AGENDA
REGULAR ZONING BOARD MEETING
Public Meeting Room, Village Hall
Tuesday, April 11, 2017
7:00 p.m.

3.1 PUBLIC HEARING regarding a request for a Major Amendment to an existing Special Use Permit to construct a proposed 50,000 square foot building addition, with Zoning variances for Adlai E. Stevenson High School District 125, 1 Stevenson Drive (Stevenson High School District 125).

Figure 7

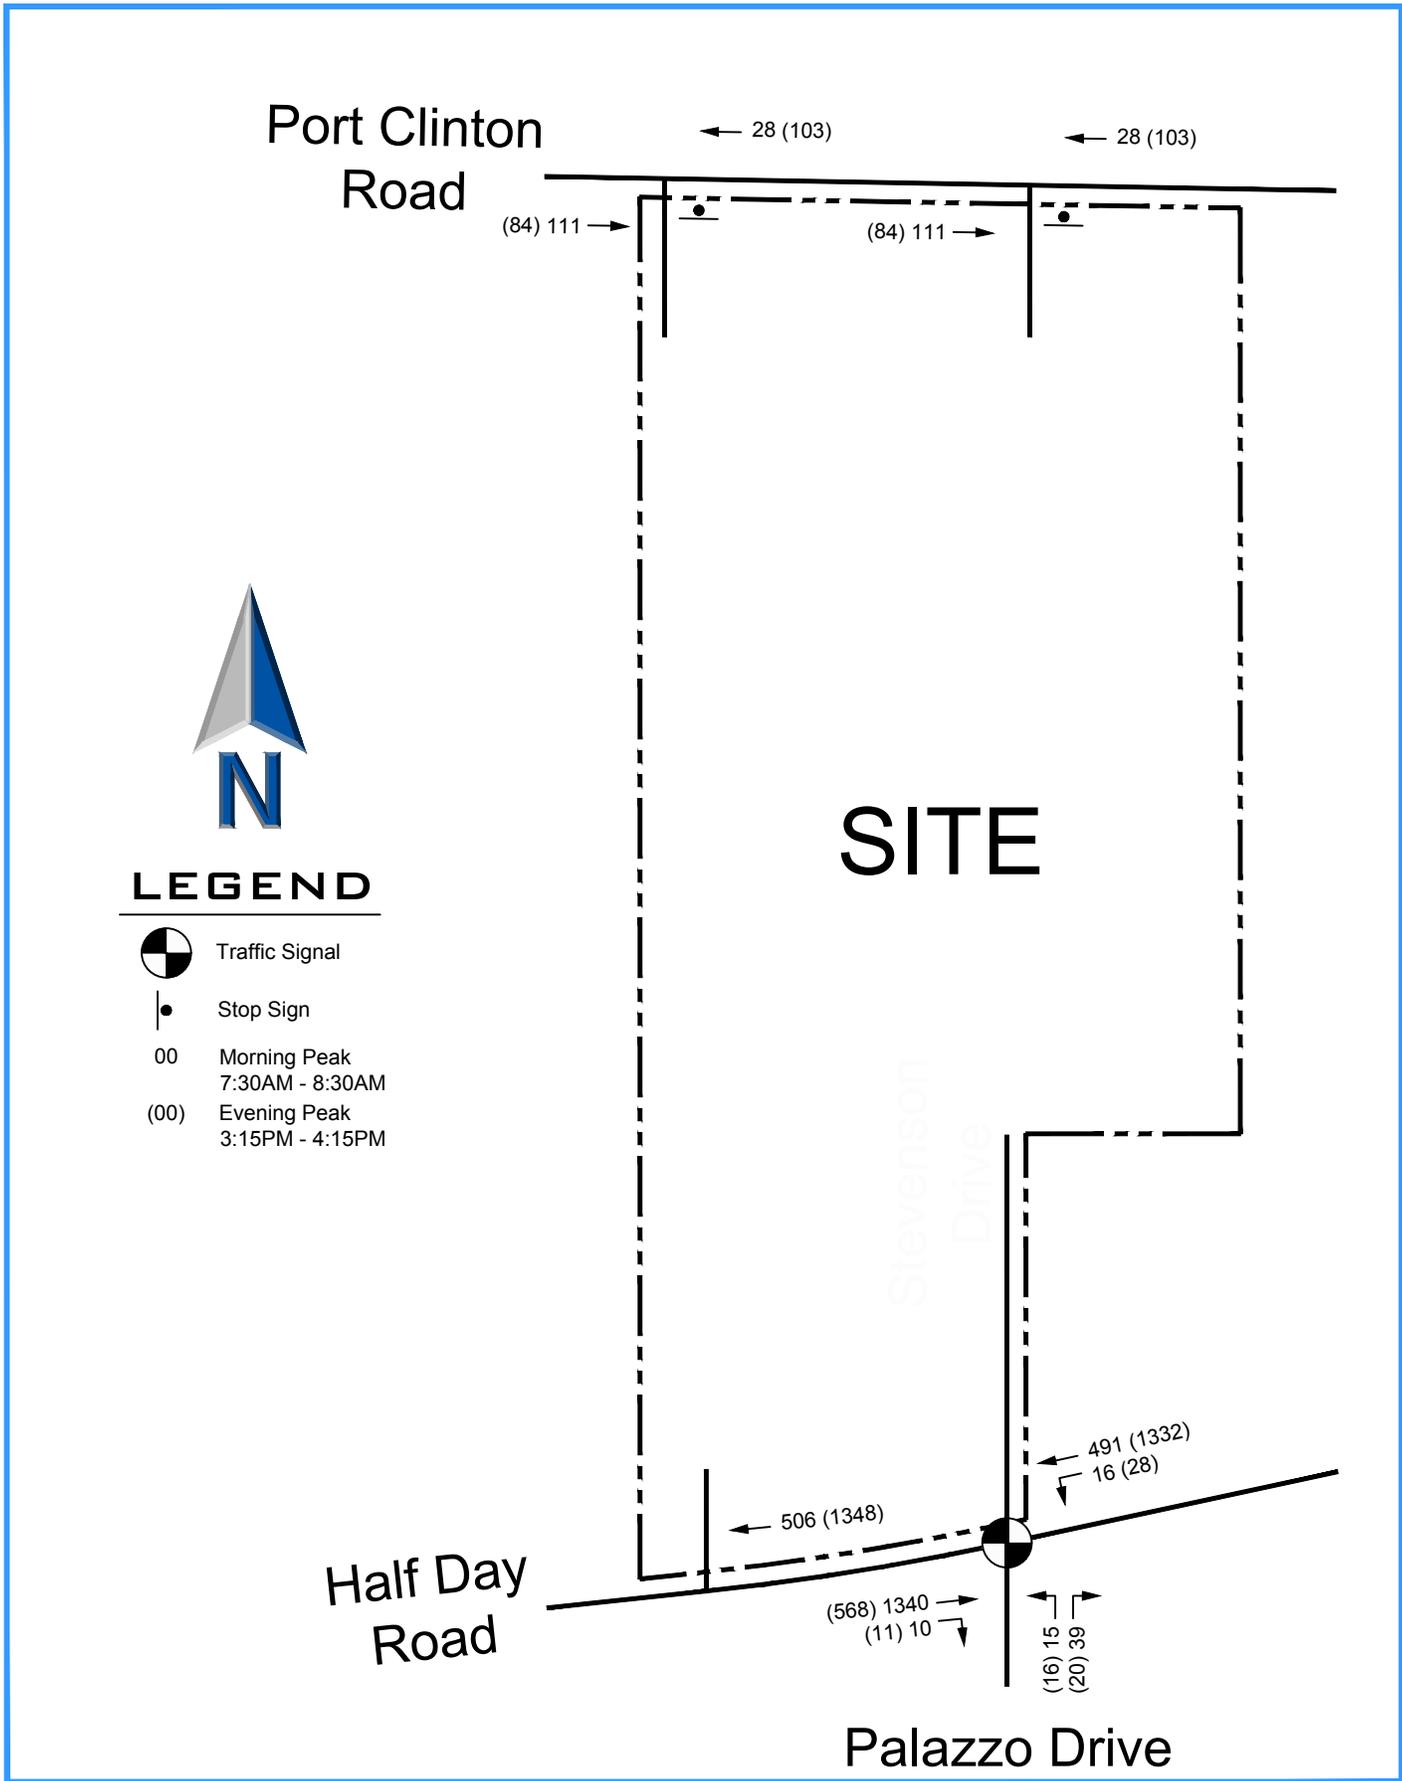
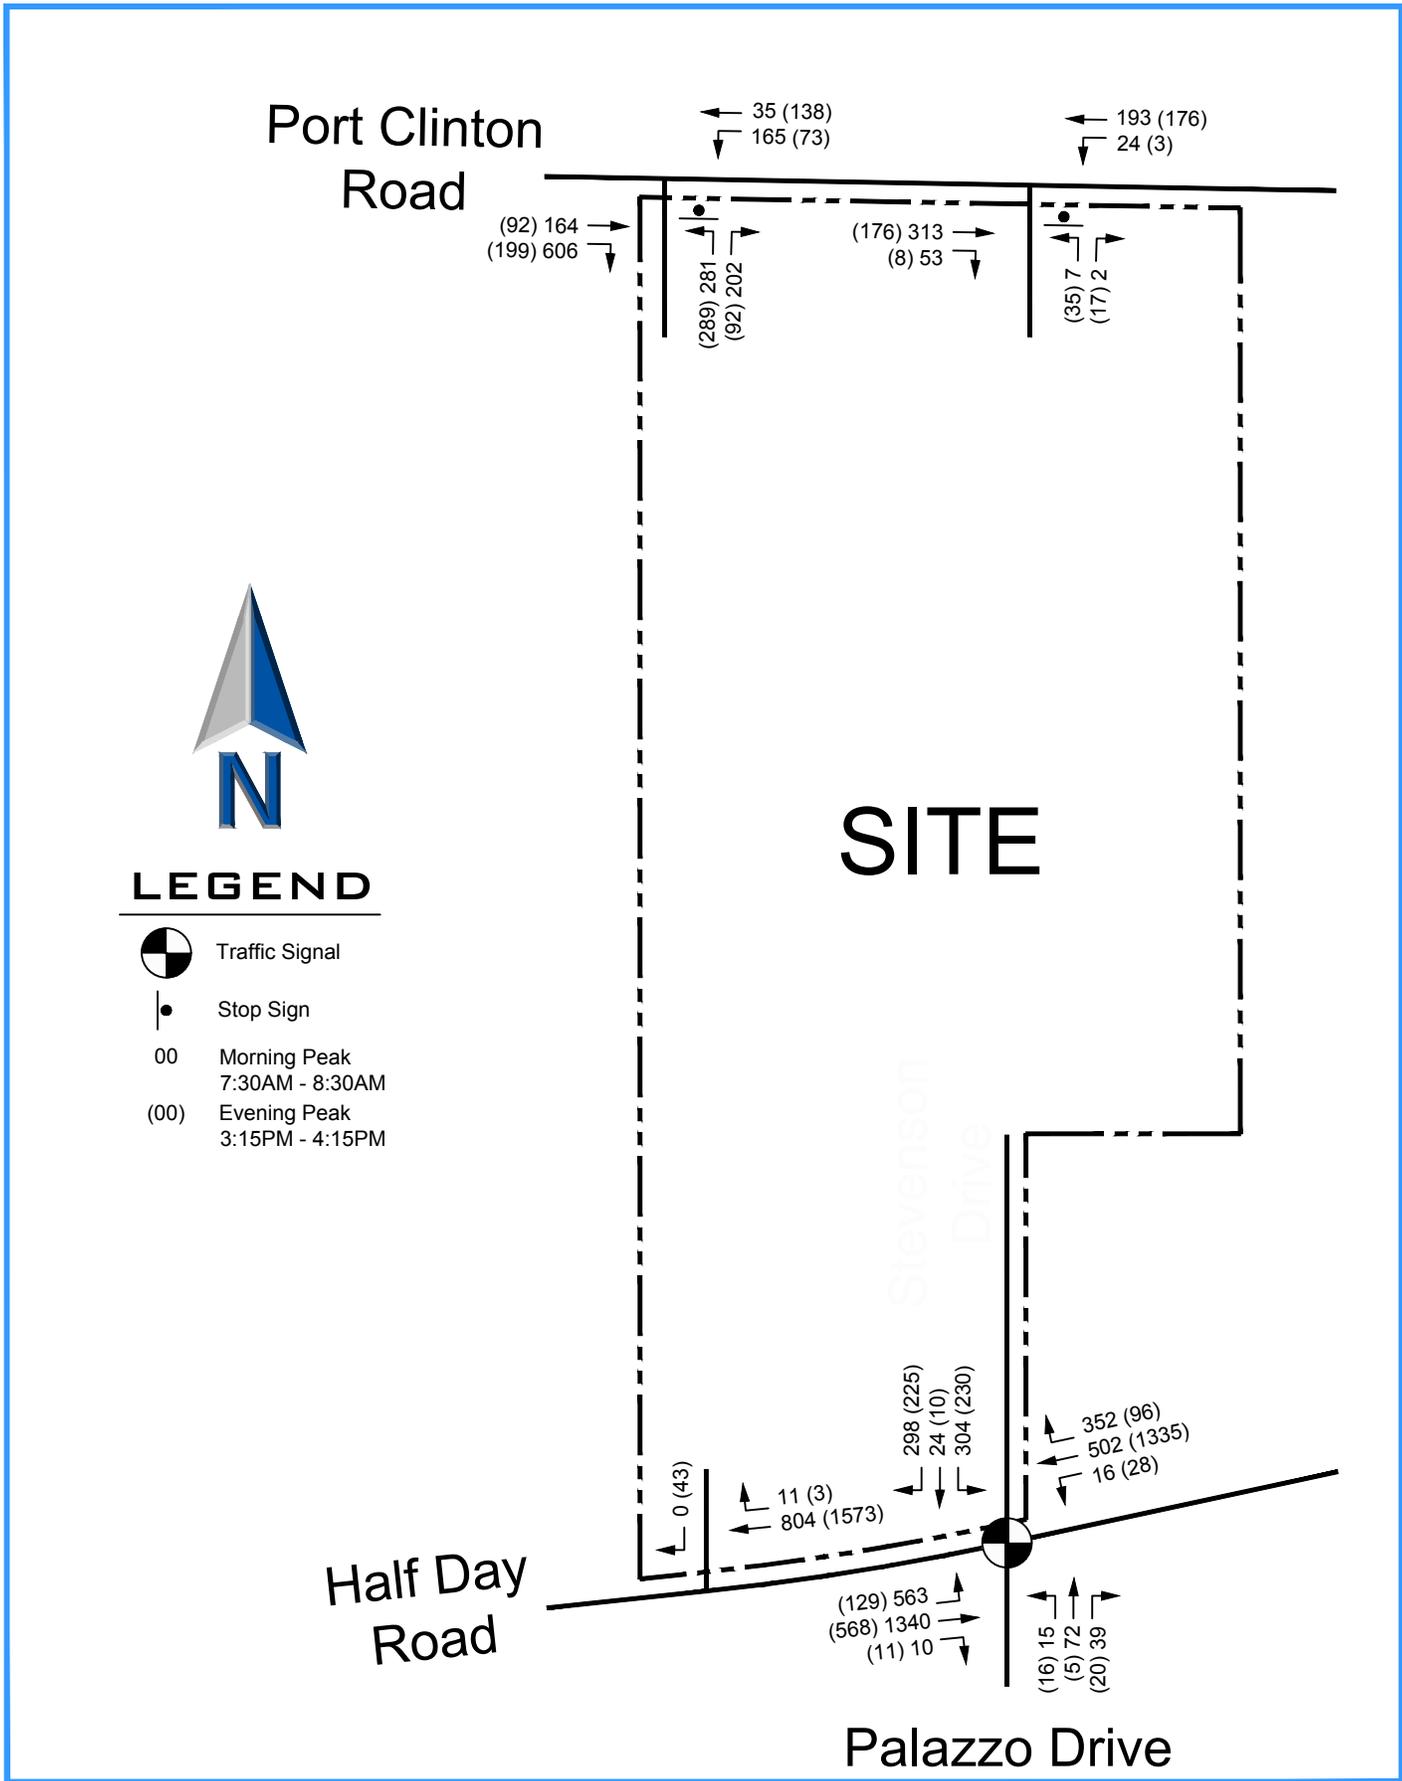
1) Can you quantify how much traffic is expected to be removed from Route 22 due to the Port Clinton proposed improvements?

Response: Figure 7 of the report shows the estimated diversion of traffic from Route 22 to Port Clinton Road at 110 vehicles per hour for the morning arrival and 40 vehicles per hour during the afternoon dismissal.
